Access Compliance Report

Public Rights-of-Way

(Pedestrian Signals)

Intersection ID: N/A	Main Street:	Cross Street: N/A	Location: N/A
ADA ID: 1EC0CCCB4D06	Signal Type: One Push Button-APS	Overall Compliance: No	Severity Score: BTN 1: N/A BTN 2: N/A No BTN: N/A
Codes/Mitigation Info/Possible Solution		Field Measurements/Component Compliance

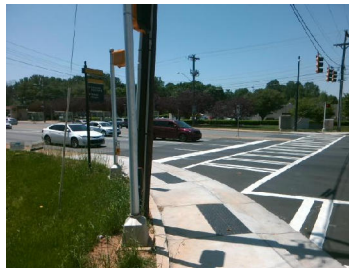
PROW/ADA: R404.2, R404.3, R404.7.3,
R209.1, MUTCD 4e.10,

Compliance	Description	Data	Compliance	Description	Data
	Button Count	Button1	Yes	Distant to Additional Button (in)	142.0
	Additional Button Present?	Yes		Additional Button ID	CDE04555FD6B
N/A	Signal Buttons Required?	N/A	N/A	Additional Ped Posts Required	N/A
	How Many Ped Street Xings?	1		Located In An Island/Median?	No
N/A	B 1 Sign Present?	Yes	N/A	B 2 Sign Present?	N/A
Yes	B 1 Sign Purpose?	Yes	N/A	B 2 Sign Purpose?	N/A
Yes	B 1 Sign Lettering & Contrast?	Yes	N/A	B 2 Sign Lettering & Contrast?	N/A
Yes	B 1 Parallel To XWalk?	Yes	N/A	B 2 Parallel To XWalk?	N/A
Yes	B 1 PAR to Button?	Yes	N/A	B 2 PAR to Button?	N/A
Yes	B 1 PAR to XWalk?	Yes	N/A	B 2 PAR to XWalk?	N/A
Yes	B 1 Clear Floor Space?	Yes	N/A	B 2 Clear Floor Space?	N/A
N/A	B 1 FWD Approach?	No	N/A	B 2 FWD Approach?	N/A
N/A	B 1 FWD Approach Constrained?	No	N/A	B 2 FWD Approach Constrained?	N/A
N/A	B 1 FWD Approach Reach (in)	N/A	N/A	B 2 FWD Approach Reach (in)	N/A

N/A	B 1 FWD Approach Width (in)	N/A	N/A	B 2 FWD Approach Width (in)	N/A
N/A	B 1 FWD Approach Obstruction?	Yes	N/A	B 2 FWD Approach Obstruction?	N/A
N/A	B 1 FWD Approach Obstruction Dist (in)	4.0	N/A	B 2 FWD Approach ObstructionDist (in)	N/A
N/A	B 1 PARA Approach?	Yes	N/A	B 2 PARA Approach?	N/A
N/A	B 1 PARA Approach Constrained?	No	N/A	B 2 PARA Approach Constrained?	N/A
No	B 1 PARA Approach Reach (in)	12.0	N/A	B 2 PARA Approach Reach (in)	N/A
N/A	B 1 PARA Approach Width (in)	60.0	N/A	B 2 PARA Approach Width (in)	N/A
N/A	B 1 PARA Approach Obstruction?	Yes	N/A	B 2 PARA Approach Obstruction?	N/A
N/A	B 1 PARA Approach Obstruction Dist (in)	4.0	N/A	B 2 PARA Approach ObstructionDist (in)	N/A
No	B 1 Clear Floor Space Slope (%)	7.6	N/A	B 2 Clear Floor Space Slope (%)	N/A
Yes	B 1 Clear Floor Space XSlope (%)	1.3	N/A	B 2 Clear Floor Space XSlope (%)	N/A
N/A	B 1 PAR Slope (%)	1.6	N/A	B 2 PAR Slope (%)	N/A
Yes	B 1 Height (in)	36.0	N/A	B 2 Height (in)	N/A

Possible Solutions: Remove & Replace
Replace APS Button With New APS Button.
Remove and Replace Clear Space.
